Subject: Amendment to Water Well Ordinance, Monterey County Code –  
Chapter 15.08; File Number REF120022

Subject: August 28, 2013 1:30 PM - Water Well Ordinance (REF120022)

**RE:** Well Ordinance, Draft for Planning Commission Workshop of August 28, 2013

**Figure 1. A portion of Section C-C' from Kennedy-Jenks (2004) Hydrostratigraphic study for MCWRA.**

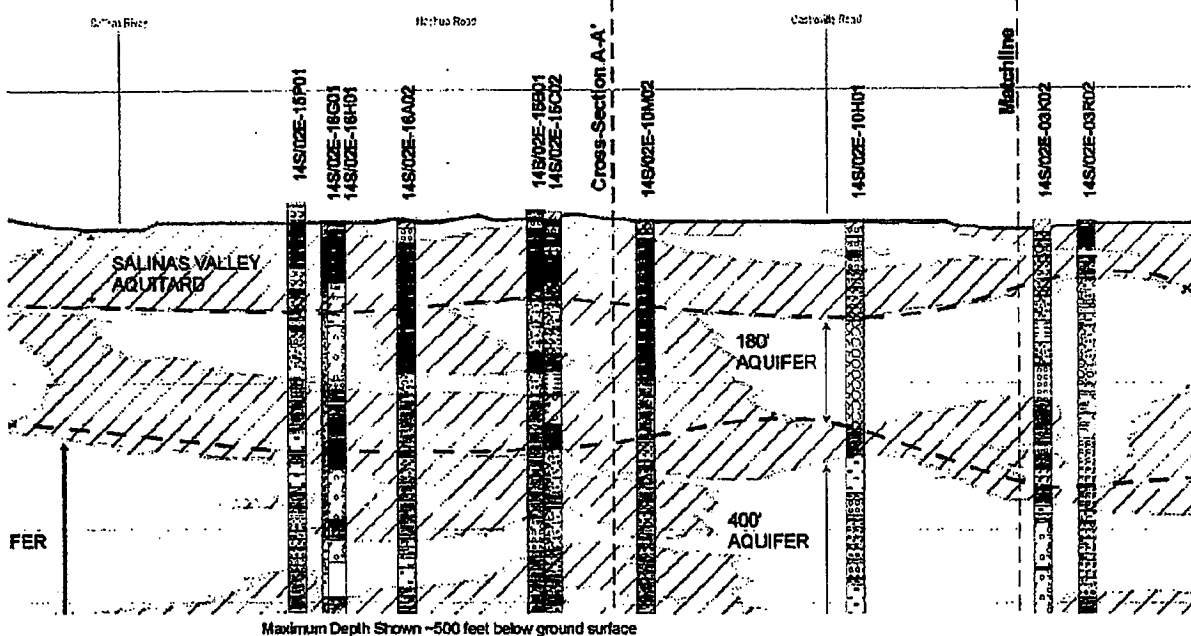
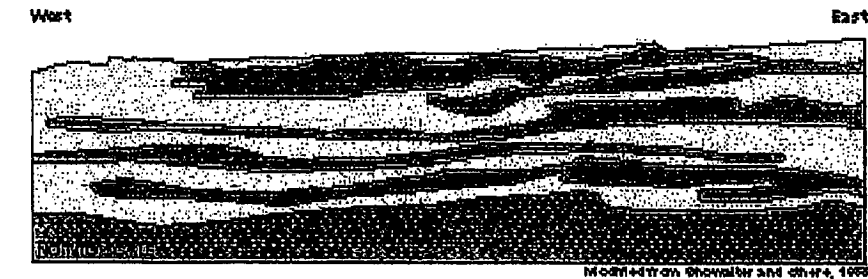
The cross-sections prepared by Kenney-Jenks (2004) for MCWRA, and that can be downloaded from the MCWRA website, show the complex nature of the aquifers and low permeability layers (aquitards) in the Valley sediments. Figure 1 (attached at the end of this letter) shows a representative part of cross-section C-C' in the Pressure Area from the Kennedy-Jenks study. The complete section C-C'' from that report is too large in size and fine in detail to show the entire section in a figure to be included in this letter. The K-J 2004 study covers only the northern Pressure Area, but similar detailed sections should be developed for the entire Valley so that they can be used by the Agency to evaluate new wells, and so that they can be reviewed by the public. The Board is encouraged to review all of the cross-sections in that study and those of a similar stratigraphic study of the basin by Fugro in late 1990s that covered a larger area of the Valley.

Figure 1 shows the presence of various blue and brown colored low permeability zones specified in each graphic well log, from the surface down to 500 feet. The K-J 2004 correlations highlight the thicker zones, but there are many fine grained layers throughout the Salinas Valley that limit, or prevent, vertical flow and hydraulic communication between productive aquifers at depth and nearby stream beds. Geologic sections such as these, and

Figure 3. From the Hunt 1999 paper on which the Agency Tier I stream depletion model is based. It represents a single aquifer with no leaky aquifer or aquitard below.

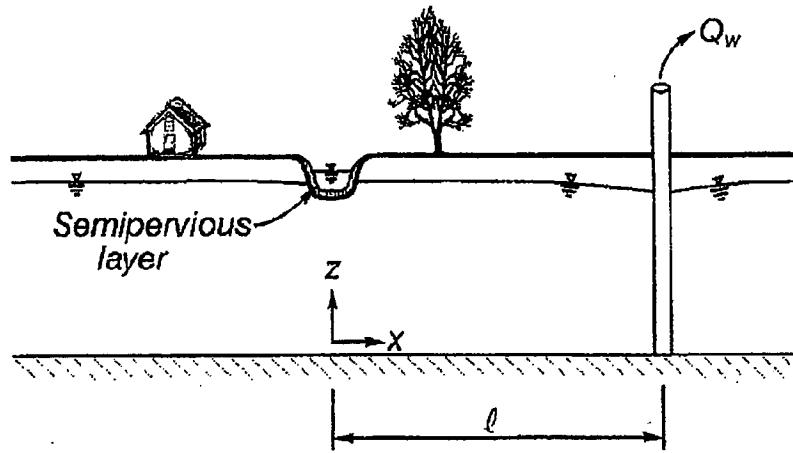
Figure 2, below, is from a USGS report on the Salinas Valley. It is generalized, but represents the presence of alternating aquifers and aquitards that occur throughout the Valley, and are thickest in the northern part of the basin. Figure 3, below, is from the Hunt 1999 paper on which the Tier I model, used by the Agency, is based. It shows a single aquifer in perfect hydraulic communication with the stream bed. The Hunt models in no way account for low permeability layers below the stream bed or for multiple aquifers. Even a brief review confirms that the Hunt 1999 model does not represent the conditions in the Salinas Valley for all but very shallow wells near the Salinas River. The Hunt 2003 model is similarly limited, as are all 2D analytical models.

Figure 4. Calibrated analytical stream flow depletion from USGS WRI 00-4029

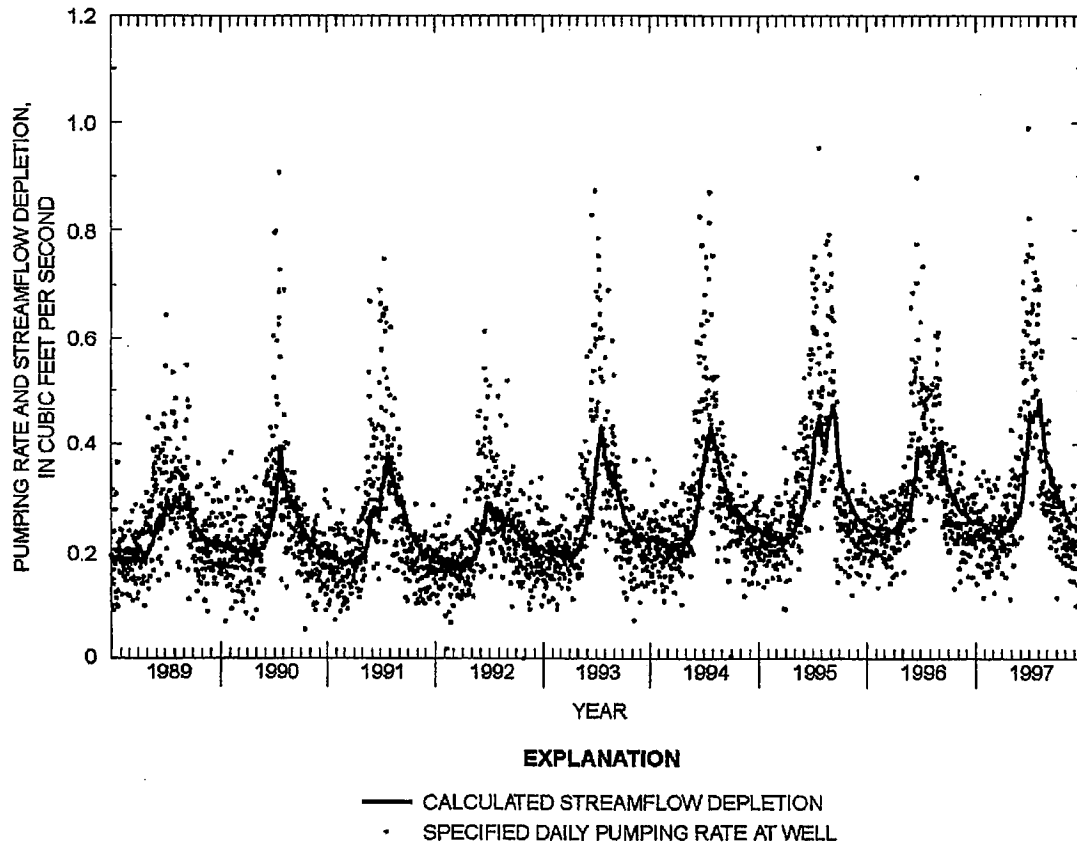
Before the USGS applied the analytical model to their study area, they calibrated it to the flows of the nearby river using actual well extraction data. Figure 4, below, is from Appendix A of the USGS (2000) report. It shows the results of their calibration of a 2D model developed for use in a basin in Massachusetts. With the model calibrated, they were able to establish that, in that study area, there was excellent hydraulic communication between the well and the stream. One of the reasons this method could be applied effectively is that that study area in Massachusetts has a shallow groundwater system. In that area bedrock occurs at depths below about 45 feet and there is good hydraulic communication between the aquifer and the river, unlike conditions in the Salinas Valley.

**Figure 5. Seasonal Pumping Rate Distribution for a 1000 gpm well.**

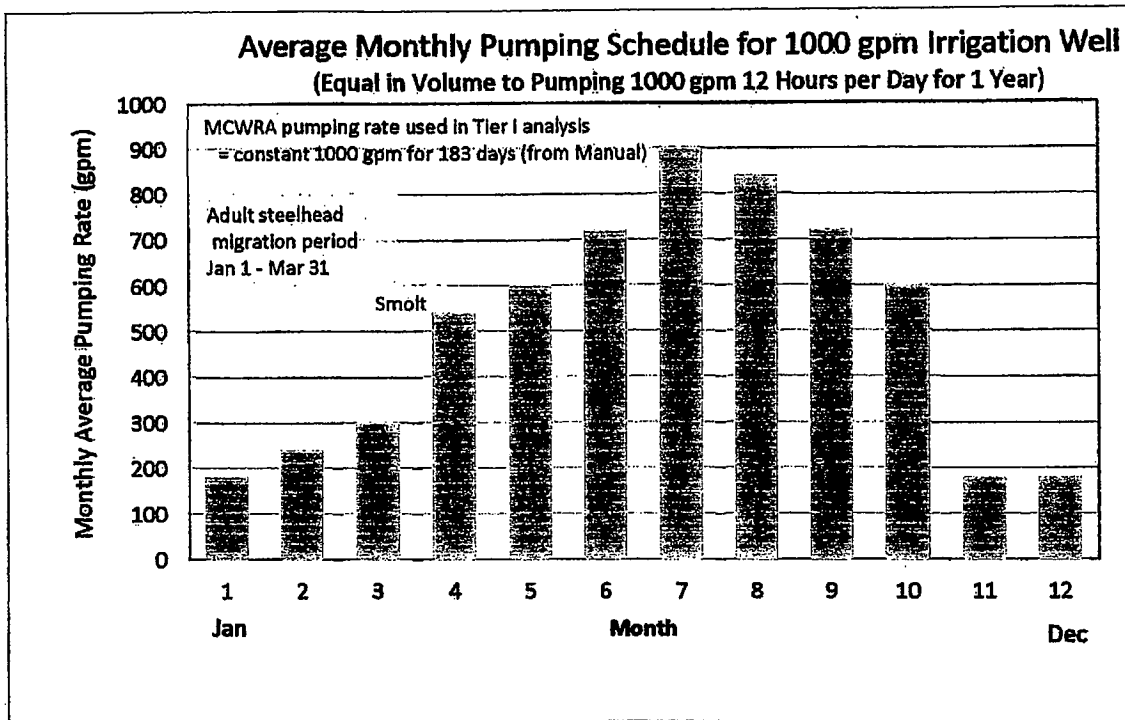
pumping distribution should be used. A footnote in the Draft Administrative Manual (dated 5/17/12), indicates the Tier I calculation represents intermittent pumping over a period of one year by simulating continuous pumping for 183 days. That may have changed as part of "refinements", but the revised pumping distribution that is currently used has not been made public or demonstrated to show that it reasonably represents well pumping during periods in which Salinas River flows are critical to fish.

The 183 day constant pumping rate distribution overestimates the potential impact of proposed wells on nearby streams. A more representative period should be used, that accounts for lower rates of pumping in winter and spring, or zero pumping in winter, if the new well will not be used during that season. An approximate monthly pumping distribution for both irrigation and domestic supply in the Salinas Valley is shown in Figure 5 below. The monthly rate shown is based on seasonal demand. These monthly average rates result in the same total volume pumped in one year as that for a well that is pumped at 1000 gpm for 12 hours per day for 365 days (500 gpm annual average). In the Manual, for Tier I, analysis states that the Agency will represent that same well as pumping 1000 gpm continuously for 183 days. This is shown in Figure 5 by the orange zone at the top of the graph. That rate does not properly represent pumping for this well at any time. In this example, the average rate for this 1000 gpm well, during the first four months of the year is about 300 gpm. If this well is represented in the Tier I analysis for the full 12 months at an average rate of 500 gpm, it does not properly represent pumping by this well during critical fish flow periods. Also, Tier I analyses should not be simulated for a 12 month period for the reasons discussed below in Item 7.

**Figure 6. Example of a well pumping 1000 gpm in Salinas Valley with the effects of the regional groundwater gradient.**

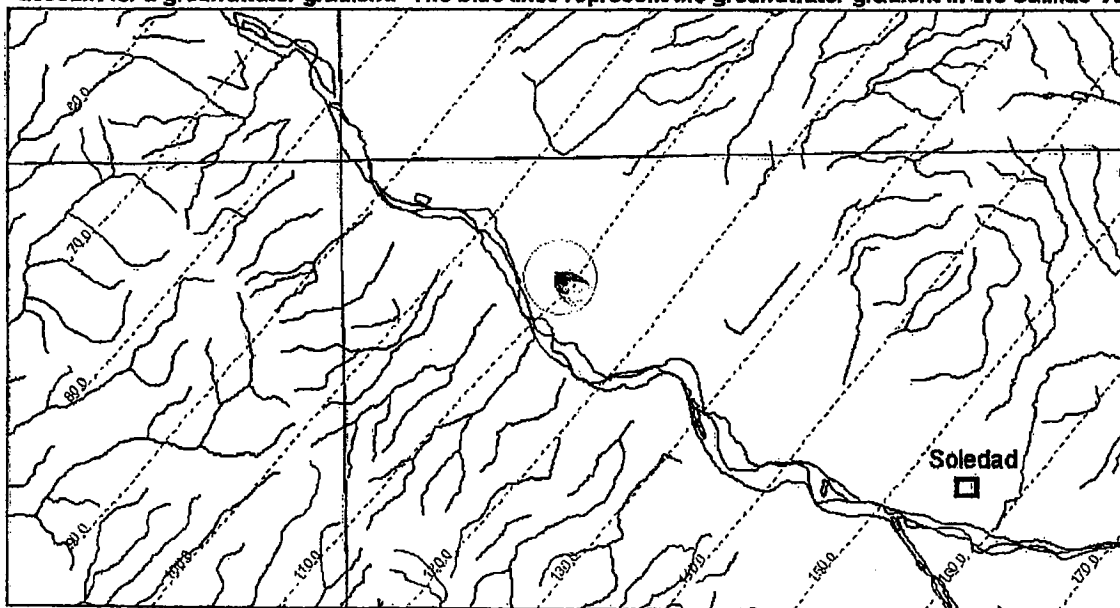
10. The groundwater gradient affects the source of water pumped by wells, even those wells that are close to a stream. The groundwater gradient is another reason 2D stream depletion models, including Hunt 1999 and 2003, do not correctly simulate stream depletion in the Salinas Valley. The effect of the gradient is shown in the Figure 6, below. It shows a well located near the Salinas River between Soledad and Greenfield that has been pumped continuously at 1000 gpm for one year. The slope of the actual Salinas Valley groundwater gradient for this area is

included in this model. The gradient shown was determined from maps that can be downloaded from the MCWRA website and is represented in the figure by the blue groundwater elevation contour lines. The water produced by the well comes from up gradient, not from an ever expanding circular region that will ultimately intercept the River. Other analytical stream depletion models have the same limitation. In Figure 6, this expanding circle is represented by the red circle around the well that is not part of the model calculation, but was added later for this example. The expanding circular region of influence of a well is what is simulated by the Hunt 1999 model. A figure from the Hunt 1999 paper that shows the expanding circular region is included as Figure 7, below.

If the Hunt model were used in this example, the red circle in Figure 6 would eventually expand to contact the Salinas River bed and simulate that all of the flow to the well will come from the River. However, the actual source area and cone of depression for this well will never intersect the River unless the pumping rate was increased by a factor of 3 to 5, and continued without interruption for a very long period.

The example in Figure 6 is output from a 2D well head protection model (WhAEM2000). It is not suggested for evaluation of stream depletion because it cannot account for which zone a well is pumping from, and how many low permeability layers overly that production zone that may limit or prevent stream depletion. The model was developed by the EPA for use in designing capture zones for well fields for extract contaminants, and to allow identification of source areas for wells that may be down gradient from contaminant sites. If there are complex aquifers and multiple zones that cannot be accounted for using 2D models, the EPA will require the use of the 3D numerical model.
